Siji Garment Co Ltd.

S.A Plot -47, Kewa,Sreepur, Gazipur

Observations

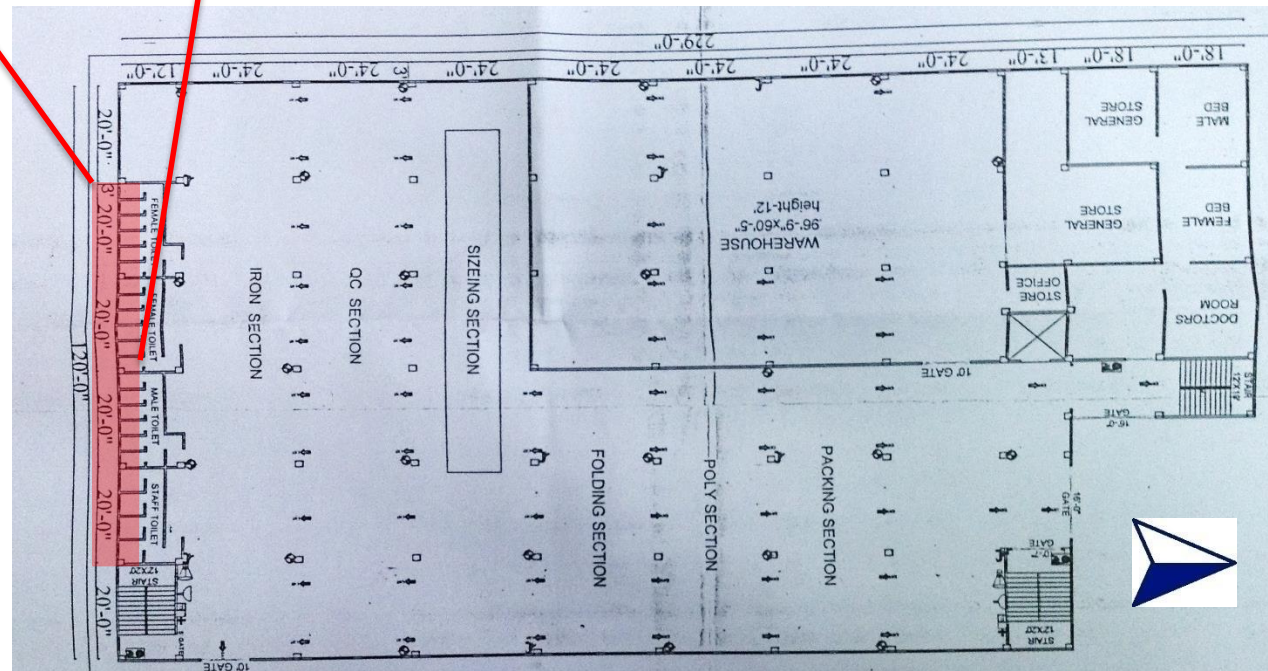
Build-ups in toilets' corridors 65mm

Build-ups in toilets' 230mm (total)

175mm + 65mm build ups observed in the toilet area.

Cracks in the ground floor toilet area

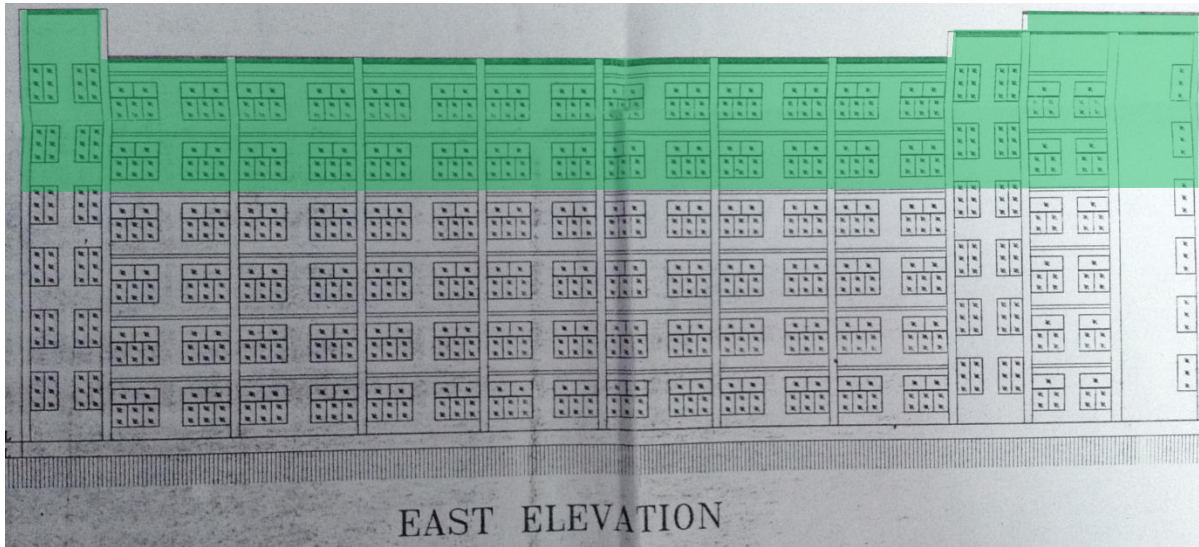
Crack observed in the external brick wall of the toilet area at Ground Floor.

Crack on the partitions are observed in the toilet area .

Toilet area appears to be on own footings at ground floor

Item No.	Observation	Recommended Action Plan	Recommended Timeline
1	Very large loads on columns of Building 1 & 3 after additional floor construction	Factory Engineer to review design , loads and all column stresses and confirm in situ concrete strength by taking 4 No 100mm cores if extension to proceed.	6-weeks
2	Very large loads on columns of Building 1 & 3 after additional floor construction	Upward extension should be put on hold until the completion of the engineering review	6-weeks
3	Very large loads on columns of Building 1 & 3 after additional floor construction	Carry out the recommendations of the review.	6-months
4	Cracks in the masonry wall in the toilet zone Building 1	Factory Engineer to investigate cracks in ground floor toilet masonry wall and review effectiveness of wall foundations.	6-weeks
5	Cracks in the masonry wall in the toilet zone Building 1	Carry out remedial works	6-months

Discrepancies between permit drawings

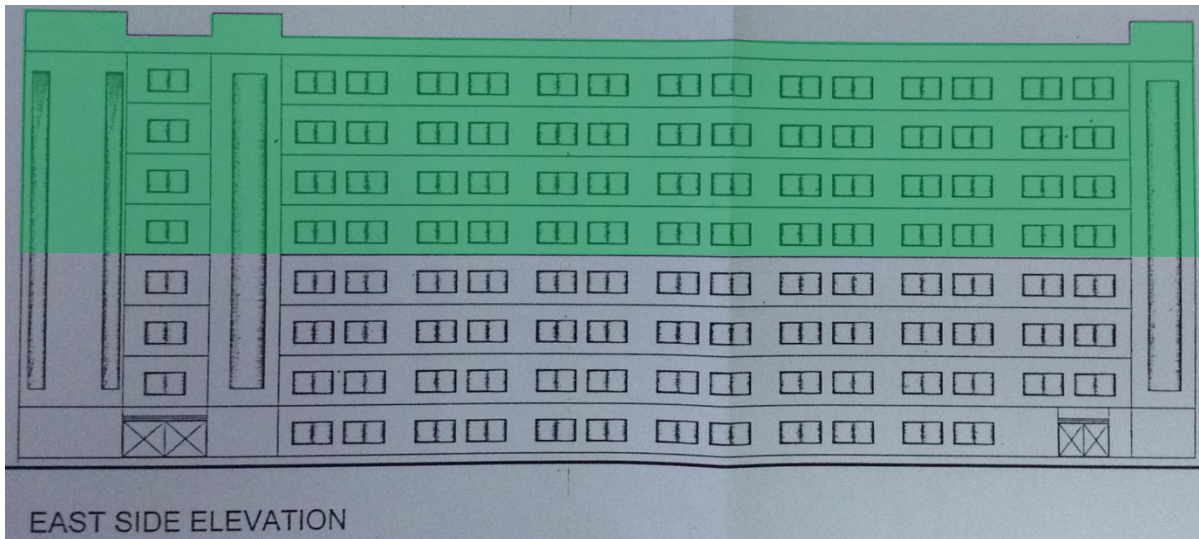
The permit drawing shows 6-storey structure for the Main Building

The industrial permit drawing shows 8-storey structure for the Main Building

Discrepancies between two permit drawings.
